RESPONSE TO REQUEST FOR ADDITIONAL INFORMATION

APR1400 Design Certification

RAI No.: 395-8478

SRP Section: 15.06.01 - Inadvertent Opening of a PWR Pressurizer Pressure Relief Valve or a BWR Pressure Relief Valve

Figure 1 POSRV Schematic Diagram

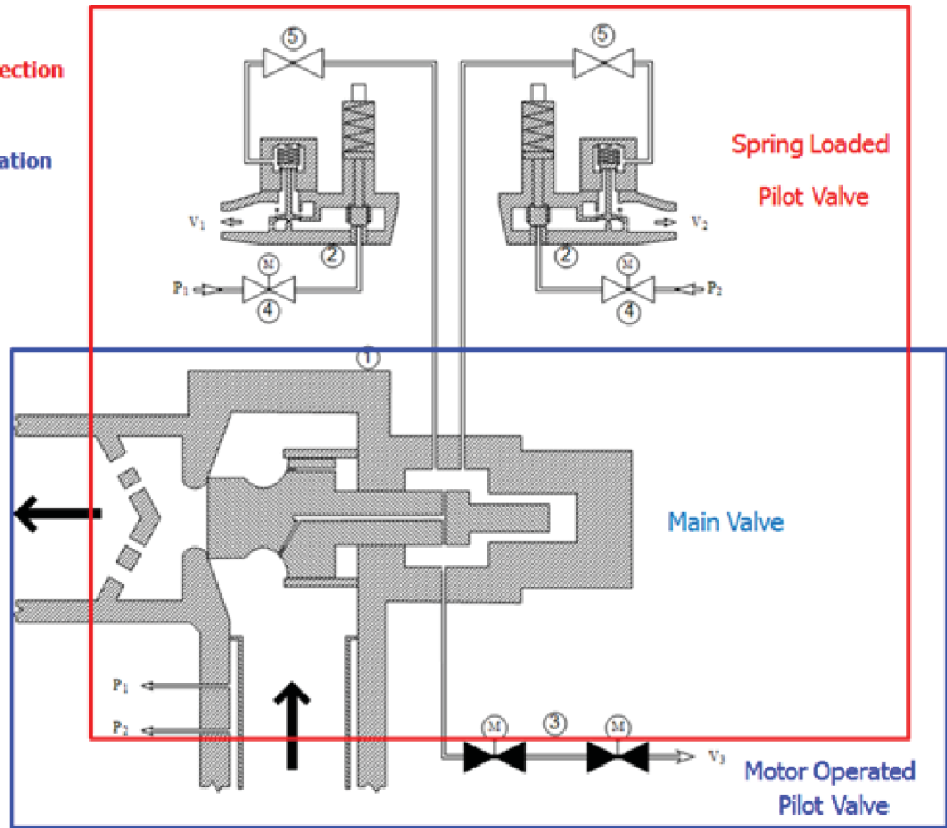
design.” NRC staff understands that the overpressure protection function of the pilot operated safety relief valves (POSRVs) is fully automatic and passive. NRC staff’s concern is in regard to the double motor operated pilot valves which can be manually operated from the control room. The RAI response does not address the potential for a spurious electrical signal or operator error, in regards to the operation of the double motor operated pilot valves, which would lead to an IOPRV event.

NRC staff requests that KHNP update Section 15.6.1 of the DCD with justification for stating that a spurious electrical signal or operator error is not applicable to the APR1400. If sufficient justification is not available, Section 15.6.1 of the DCD will need to be updated with an appropriate analysis to demonstrate compliance with the Commission’s regulations that underlie SRP Section 15.6.1. Additionally, Table 1.9-2 of the DCD needs to be updated accordingly.

3. The POSRVs perform both the overpressure protection function and the rapid depressurization function. The spring loaded pilot valve and the main valve in the POSRV perform the overpressure protection function using the passive hydraulic mechanism. Whereas, the motor operated pilot valves and the main valve in the POSRV perform the rapid depressurization function using the manual operation during the feed and bleed operation in a total loss of feedwater event. A schematic diagram of the POSRV is shown in Figure 1.

To prevent POSRVs from opening due to a spurious electrical signal or operator error, one of the two motor operated pilot valves is designed to be powered off during the normal operation as is described in DCD TIER 2, Chapter 16 Tech. Spec., Section 3.4.10 Pressurizer Pilot Operated Safety Relief Valves (POSRVs), SR 3.4.10.2.
